MCPB
Item # 2
12/20/01

MEMORANDUM

REVIEW TYPE: Development Plan Amendment
REVIEW BASIS: Chapter 59, Zoning Ordinance
APPLICANT: Hunt Family Limited Partnership
CASE NUMBER: DPA 02-1

SUBJECT: Special Protection Area (SPA) Preliminary Water
Quality Plan for Hunt-Miles Property (associated with Development
Plan Amendment DPA 02-1)

Development Plan Amendment

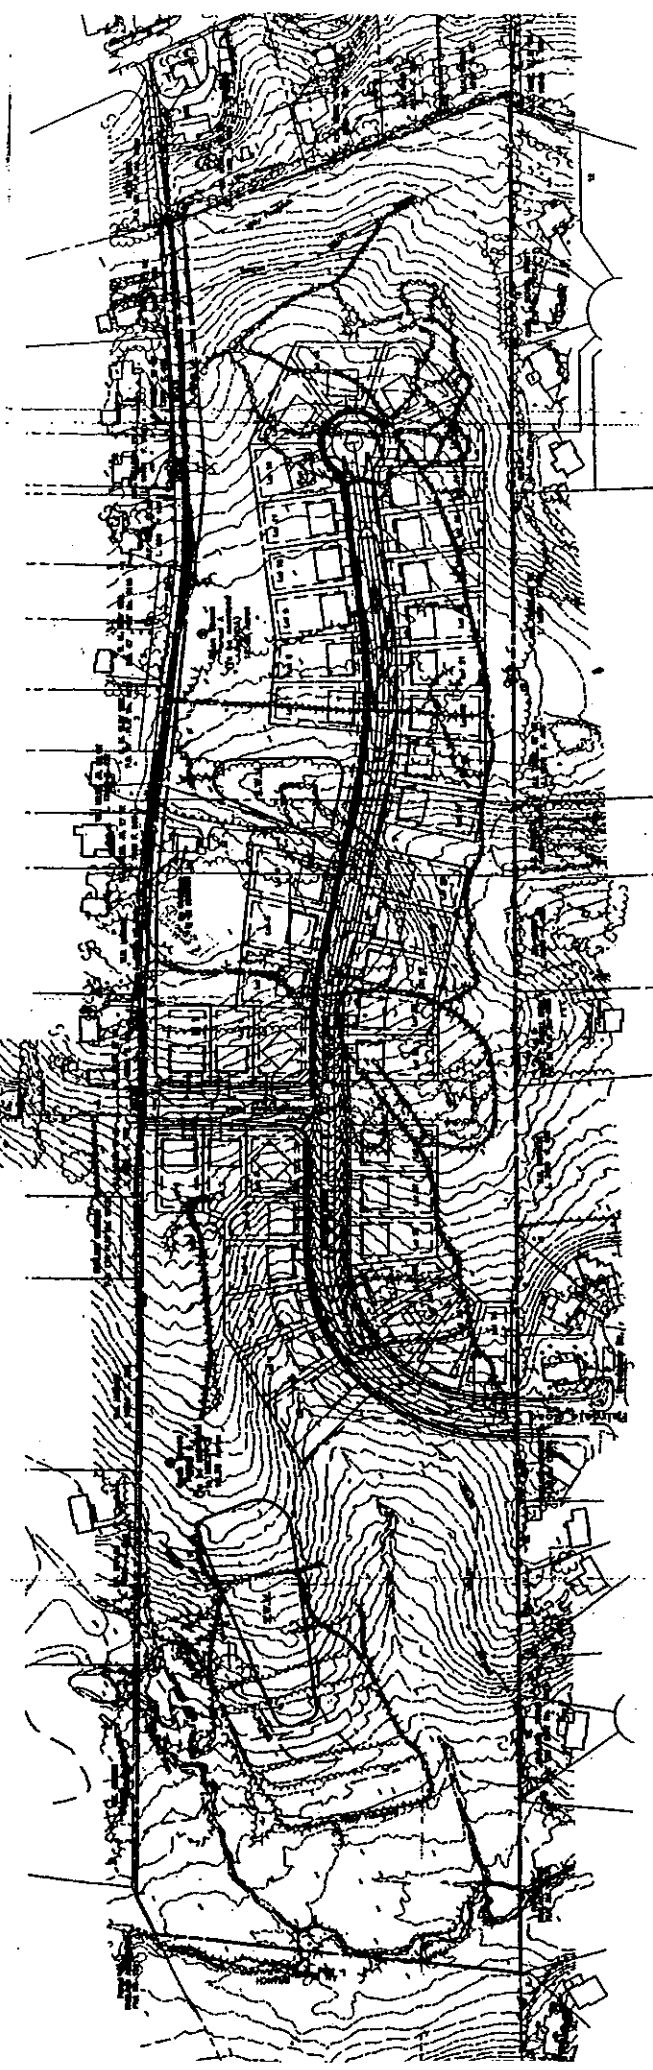
The amended development plan illustrates that Fairdale Road to the south will extend into the subject site and Friendlywood Road will extend into the property from the north in the future. Currently, an approximate 170-foot break/gap exists between the subject site and Friendlywood Road. The completion of Friendlywood Road will occur when the intervening property is subdivided and roadway is dedicated to complete the connection. Access to the property will be via Fairdale Road from Briggs Chaney Road, until the off-site connection is complete. No new connections to Miles Road are proposed.

Single-family detached dwellings are proposed for both sides of the modified "S" shaped Fairdale Road, which cul-de-sacs to the east. Additionally, two stormwater management facilities are proposed for the site and more than 16 acres on the western portion of the site will be dedicated as parkland (*See attachment for Development Plan Amendment*).

The proposed development amendment indicates extending Fairdale Road to the north, which then turns eastward terminating into a cul-de-sac. Additionally, Friendlywood Road is proposed to extend into the subject property from the north and only single-family detached dwellings will be developed on the site. Both roads, when completed, will completely link the proposed development to the surrounding neighborhood. Hence, the proposal is consistent with the goals of the Fairland Master Plan.

This application has an approved NRI/FSD and has received Preliminary Forest Conservation Plan approval with the conditions that the western SWM facility is reconfigured so that there is no grading within the environmental buffer except for the SWM facility outfall pipe. Further, Category I conservation easements be placed over environmental buffers and forest-save areas that lie outside park dedication areas. Easements shall be shown on record plats. *(See Environmental Planning SPA memo for more information).*

Two stormwater management (SWM) facilities are proposed for the subject site: A SWM facility on the western portion of the site and another close to the center of the site. Environmental Planning staff recommends that the proposed western stormwater management facility be dedicated to Maryland-National Capital Park and Planning Commission (M-NCPPC).

1. At site plan, submit a final water quality plan that demonstrates that the site imperviousness will be no more than 10 percent.
2. Western stormwater management facility and surrounding environmental buffer and open space to be dedicated as M-NCPPC parkland.
3. Provide funding to be used by M-NCPPC Department of Park and Planning to cover the costs of inspection and maintenance of the western stormwater management facility. Amount of funding and timing of payments to be reviewed and approved by M-NCPPC staff prior to approval of record plats.

Development Plan Amendment

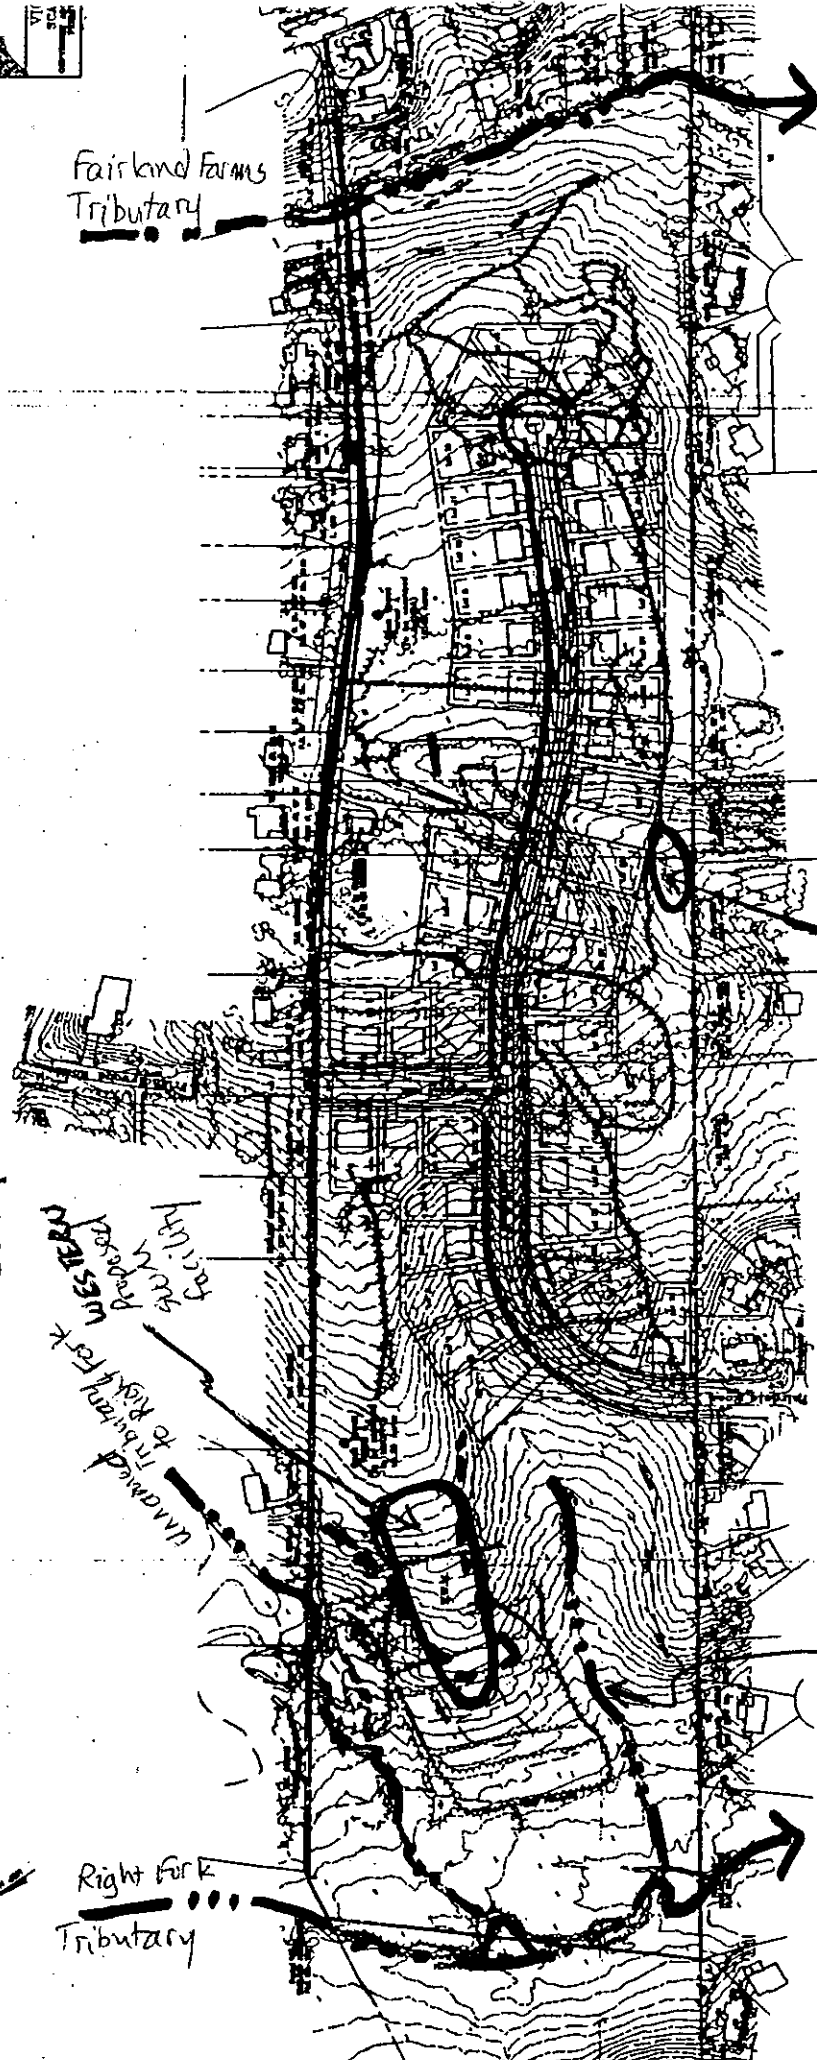
Environmental buffers are located on the western and eastern ends of the site. The eastern environmental buffer and some adjacent upland area are proposed to be in HOA common open space as a forest preservation area (i.e., Category I conservation easement area). This is acceptable to staff.

The western environmental buffer area and some adjacent upland forest are proposed to be dedicated as M-NCPPC parkland. This is acceptable to staff.

The applicant proposes to locate a stormwater management (SWM) facility in such a way that there would be about 11,500 square feet (0.26 acre) of grading within the western environmental buffer. Most (about 9270 s.f.) of this proposed buffer encroachment is currently not forested and the forest loss (about 2230 s.f.) within the buffer is for a necessary outfall pipe for the SWM facility.

Although the forest loss within the environmental buffer resulting from the applicant's proposed location of the SWM facility and its outfall pipe is small, staff believes that the SWM facility should be reconfigured to avoid any grading within the buffer area except for the necessary outfall pipe. If the SWM facility is not relocated, there would be a portion of the buffer (over 9000 s.f.) that could not be planted in forest since part of the facility's dam embankment would be in the buffer and Montgomery County Department of Permitting Services does not allow trees on such embankments. By relocating the facility outside the buffer, forest

could be planted or be allowed to naturally regenerate within the entirety of the buffer. The relocation would not affect the proposed layout of the subdivision nor the facility's effectiveness as a SWM control structure.
